## **PLANNING DEPARTMENT PRE-SUBMITTAL MEETING INFORMATION**

**FILE NO.:** PRE25-00924

**PROJECT ADDRESS:** 9001 NE 116<sup>TH</sup> PL

**PROJECT NAME:** Juanita 2 lot Short plat

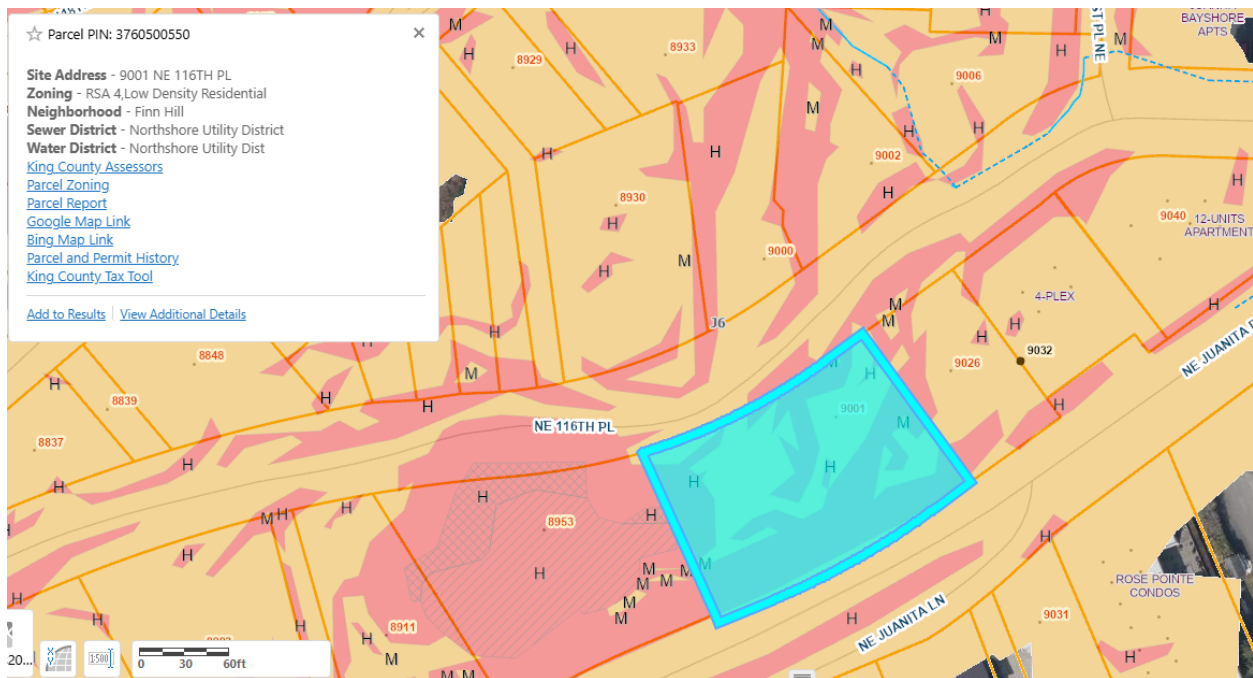
**SENSITIVE AREAS MAP:** There is a mapped stream within 125 feet of the subject property and there are also high and moderate landslide hazard areas mapped.
